**COUNTY OF ALBEMARLE STAFF
REPORT SUMMARY**

PROJECT: ZMA201900017 Woolen Mills Light Industrial Steep Slopes Amendment

TAX MAP/PARCEL: 077000000040B0

Figure 1: Areas of Slopes,

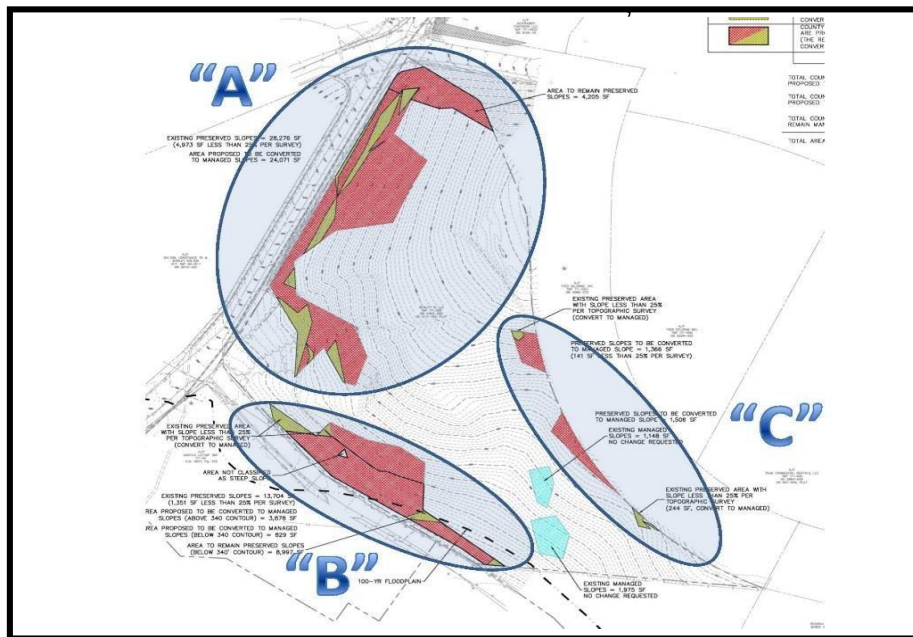
- A previous rezoning application to amend the steep slope designations on this parcel was reviewed by the Commission and Board in 2015 (ZMA201500002). That request, submitted by a different applicant, was to change three (3) distinct areas of Preserved slopes to Managed slopes and included only a small portion (about 2,731 square feet) of the 19,660 square foot area under consideration with this request. Since the 2015 application, an adjacent parcel (the old railroad parcel) containing most of the 19,660 square feet of preserved slopes was acquired and added to the TMP 07700-00-00-040B0. Therefore, most of the area under review with this current request was not reviewed with the previous application. The two other steep slope areas under review at that time were located 1) on the northwest corner of the site along Franklin Street and Broadway Street, and 2) along southern edge of Moores Creek Lane (entrance road for the sewer treatment plant). Figure 1 below shows the areas reviewed in 2015. The Board of Supervisors denied ZMA201500002 for all of the slope area requested for change.

Regarding the 2,731 square feet that is now part of current rezoning request, the staff report for ZMA201500001 stated that:

The location of the property line makes these slopes look relatively small and unimportant, but they're actually a part of a much larger system on the County's maps. Although the field run topography did show some portions of these areas as less than 25% grade, it's difficult to know if that is a more comprehensive characteristic within this system (as observed in area "A") or if it's indicative of only minor modifications along the edges of the system (as observed in area "B"). Without additional information, staff finds it appropriate to maintain these slopes as preserved slopes.

Figure 2: Non-Steep Slope Area (in red)

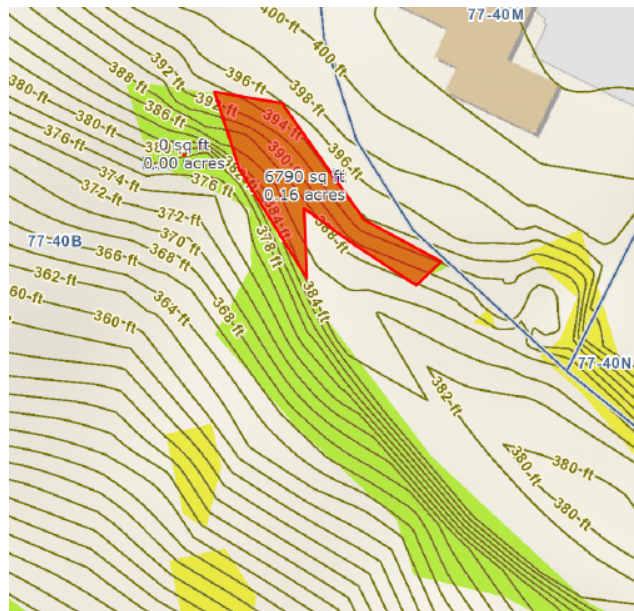
The area of preserved slopes depicted on the Steep Slopes Overlay District Map is 19,660 square feet in size. After several site visits to the area by Planning and Engineering staff, it appears that some areas designated as steep slopes/Preserved slopes are not steep slope areas (slopes less than 25 percent). The applicant has not provided more detailed field run information for this area, so there is no a specific measurement of the error, but staff estimates that approximately 5,500 to 6,500 square feet (0.16 ac.) currently designated preserved slopes are actually not steep slopes. Therefore, the actual area of steep slopes is probably in the range of 13,160 – 14,160 square feet. Figure 5 shows this general area outlined in red.

Staff also confirmed that the remaining steep slopes area is likely man-made resulting from the installation of a railroad track. Old railroad ties and property boundary monuments labeled “C&O Railroad” were observed on-site.

In analyzing this specific area, staff found characteristics of both Managed and Preserved slopes. The slopes in this area are likely manufactured, a characteristic of Managed slopes. The total “adjusted” size of this steep slope area is greater than 10,000 square feet, which is characteristic of preserved slopes.

Figure 3: Context of slopes

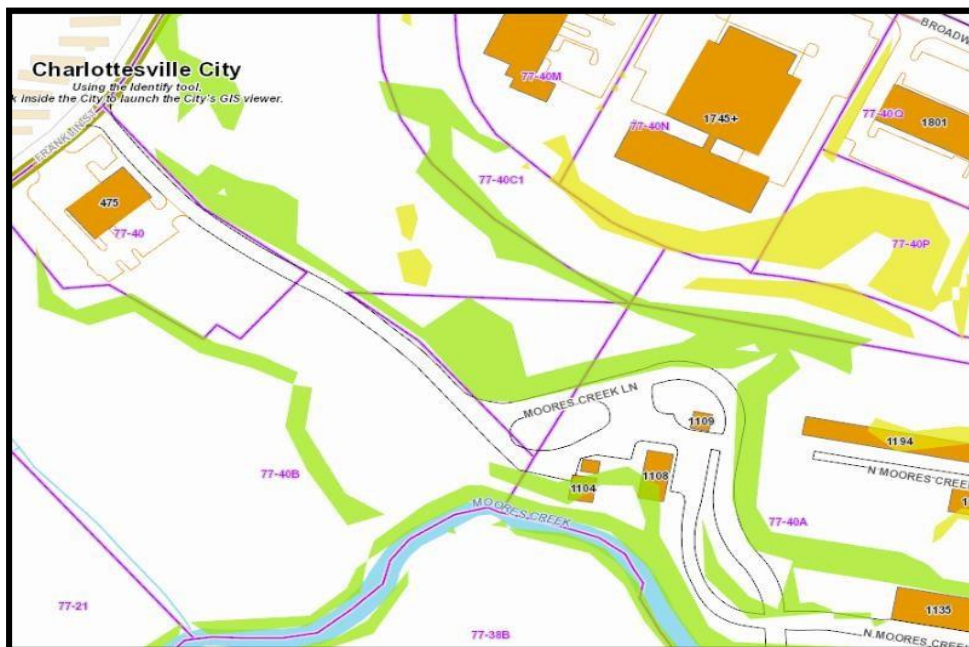
Staff also considered the context of the larger slope area. This band of manufactured slopes (generally ranging between 25 and 70 feet in width) continues eastward beyond this parcel and onto the adjacent RWSA sewer treatment plant site/property. This off-site band of manufactured slopes intersects with another band of preserved slopes on RWSA properties that runs along the edge of the floodplain of Moores Creek, and impaired stream (see Figure 3, below). This area east of the applicant’s property appears to be the more critical area to protect given its proximity to other larger preserved slope areas that are adjacent to the Moores Creek floodplain/stream buffer. That area is not proposed to be changed with this application. The upper end of the band of manufactured slopes located on the applicant’s parcel is over 250 feet distance from the 100-year floodplain and stream buffer of Moores Creek and is more removed and fragmented from other larger concentrations of Preserved slopes. These characteristics are more in keeping with the characteristics of Managed slopes.

The 19,660 square foot steep slope area on this property has characteristics of both Preserved and Managed slopes but, on balance, staff is of the opinion it has characteristics more keeping with the Managed slope designation.
